GROUP <b>BOD</b>	MODEL <b>2017MY Sorento (UMa)</b>
	NUMBER <b>151</b>	DATE <b>December 2016</b>
<b>TECHNICAL SERVICE BULLETIN</b>		
<b>SUBJECT: SERVICE ACTION: FRONT BUMPER GRILL REPLACEMENT (SA244)</b>

This bulletin provides the procedure to replace the front bumper grill on some 2017MY Sorento (UMa) vehicles, produced from April 18, 2016 to September 2, 2016, which may experience an Autonomous Emergency Braking (AEB) radar blocked message. This is due to the fact that an incorrect air intake grill was installed at the manufacturer. Follow the procedure below to replace the front bumper air intake grill. Before conducting the procedure, verify that the vehicle is included in the list of affected VINs.

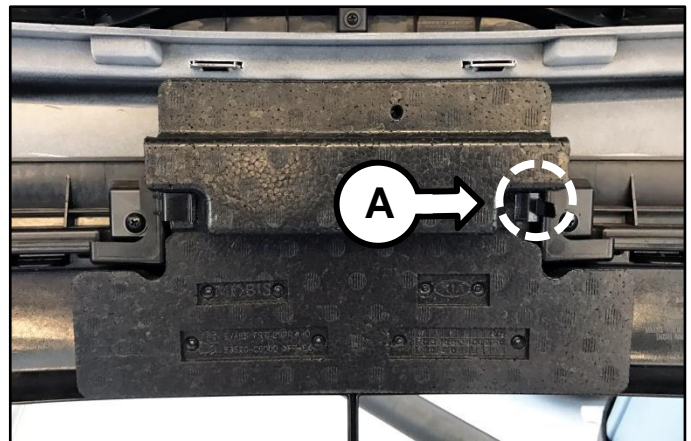
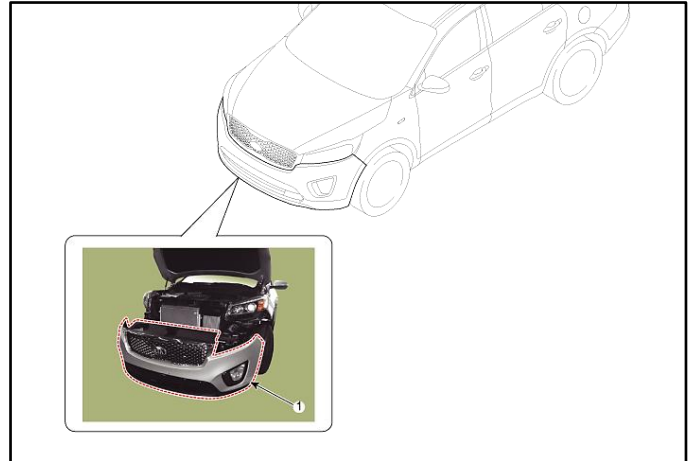
1. Remove the front bumper cover by referring to the “Body (Interior and Exterior) → Front Bumper → Front Bumper Cover → Repair Procedures” chapter in the applicable Workshop Manual on KGIS.

Place the bumper cover face down on a protective surface to prevent damage.

2. Remove the energy absorber at the center of the bumper cover by slightly pulling back the tab (A).
3. Remove the two (2) self-tapping screws located on the left and right side of the air intake grill.
4. Remove the air intake grill by carefully pulling at each end (left and right) with an upward motion, while simultaneously pushing down on the bumper cover. Unseat the air intake half way at one end and continue at the other end to remove the grill completely.

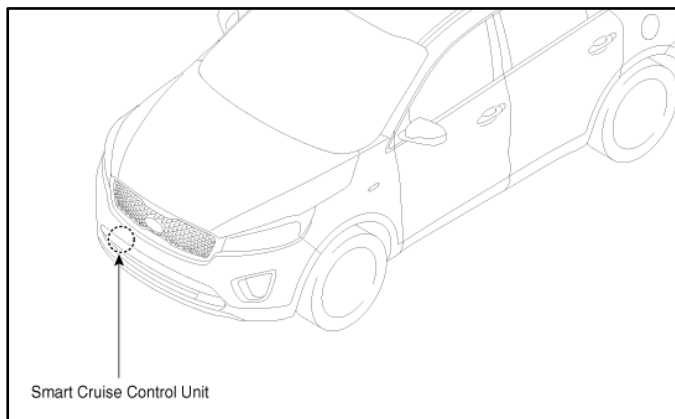
5. Place the new air intake grill in the bumper cover opening. With the tabs aligned, carefully snap the air intake grill into the bumper cover and verify that all tabs are properly seated.
